TECHNICAL BULLETIN

[Issue No.] FA-Y-0002

[Title] Specification change of Mitsubishi PLC MELSEC-Q series
Energy measuring module/Insulation monitoring module

[Relevant Models] Energy measuring module (QE81WH/QE81WH4W)、Insulation monitoring module (QE82LG)

Chart 1 : Energy measuring unit QE81WH

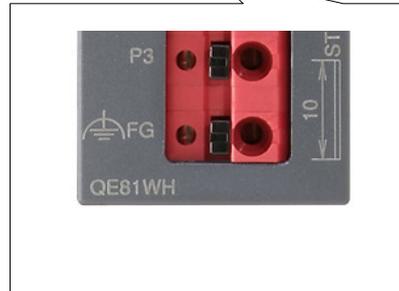
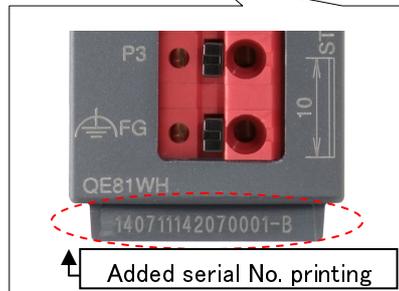
No	Item	Before the change	After the change
-	Product	Energy measuring unit	
-	Model	QE81WH	
1	GX Works2 Support	-	<p>Corresponds to GX Works2 functions below.</p> <ul style="list-style-type: none"> • Switching settings • Parameter settings • Automatic refreshment • Intelligent function unit monitoring • Use of sample comments <p>Please note that it does not correspond to H/W information display.</p>
2	Front part serial No. printing	 	  <div style="border: 1px solid black; padding: 2px; display: inline-block;"> ↑ Added serial No. printing </div>

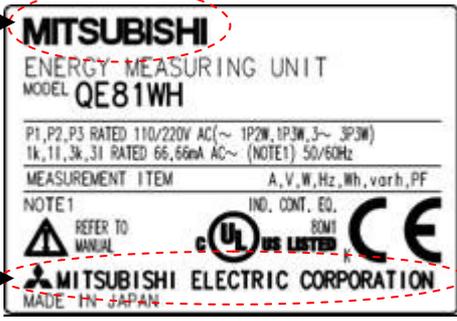
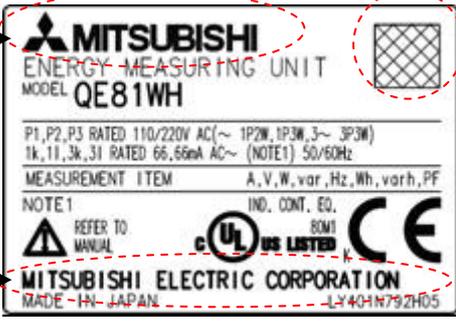
3	Change of the name plate	 <p>Before the change of corporate logo</p>	<p style="text-align: right;">Added QR code</p>  <p>After the change of corporate logo</p>
4	Addition of data acquisition clock	<p>No data acquisition clock function</p> <ul style="list-style-type: none"> • Buffer memory (address 60,61) : Not used • Input device Xn8 : Not used 	<p>Added data acquisition clock function</p> <ul style="list-style-type: none"> • Buffer memory (address 60,61) : Output cycle of data acquisition clock • Input device Xn8 : Data acquisition clock
5	Addition of reactive power measuring function	<p>No reactive power measuring function</p> <ul style="list-style-type: none"> • Buffer memory (address 500) : Not used • Buffer memory (address 502,503) : Not used 	<p>Added reactive power measuring function</p> <ul style="list-style-type: none"> • Buffer memory (address 500) : Number of decimal places of reactive power • Buffer memory (address 502,503) : Reactive power

Chart 2 : Energy measuring unit QE81WH4W

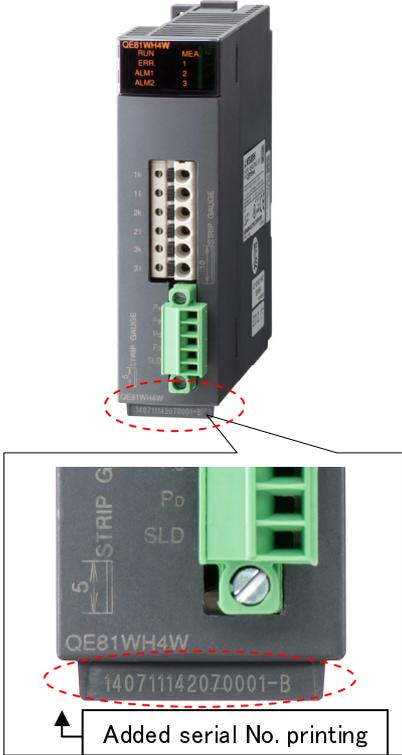
No	Item	Before the change	After the change
-	Product	Energy measuring unit	
-	Model	QE81WH	
1	GX Works2 Support	-	<p>Corresponds to GX Works2 functions below.</p> <ul style="list-style-type: none"> •Switching settings •Parameter settings •Automatic refreshment •Intelligent function unit monitoring •Use of sample comments <p>Please note that it does not correspond to H/W information display.</p>
2	Front part serial No. printing		 <p style="text-align: center;">Added serial No. printing</p>

Chart 3 : Insulation monitoring module QE82LG

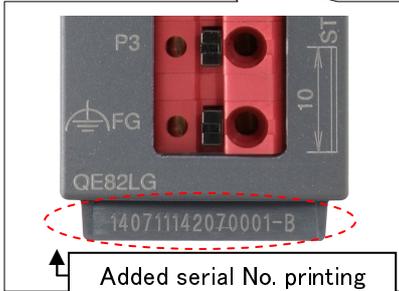
No	Item	Before the change	After the change
-	Product	Energy measuring unit	
-	Model	QE81WH	
1	GX Works2 Support	-	<p>Corresponds to GX Works2 functions below.</p> <ul style="list-style-type: none"> •Switching settings •Parameter settings •Automatic refreshment •Intelligent function unit monitoring •Use of sample comments <p>Please note that it does not correspond to H/W information display.</p>
2	Front part serial No. printing	 	  <p style="text-align: center;">↑ Added serial No. printing</p>
